Interactive comment on “Distributed model of hydrological and sediment transport processes in large river basins in Southeast Asia” by S. Zuliziana et al.

Interactive comment on Hydrol. Earth Syst. Sci. Discuss., 12, 6755, 2015.

Fig. 1. The hillslope concept in distributed hydrological model

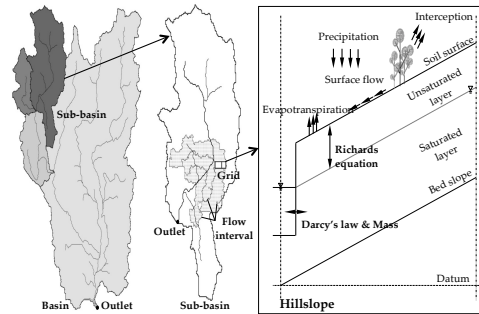
Q3. The hydrological hillslope model is based on the calculation of runoff generation in hillslope units. It remains unclear how large these units are and how the discharge is distributed across the apparently smaller grid cells of the sediment transport module.

A3. In hydrological hillslope model, the runoff was generate in hillslope units. The hillslope unit is viewed as a rectangular inclined plane with a defined length and unit width. The inclination angle givens by the corresponding surface slope. Figure 1 show the concept of hillslope based on distributed hydrological model used in this study.
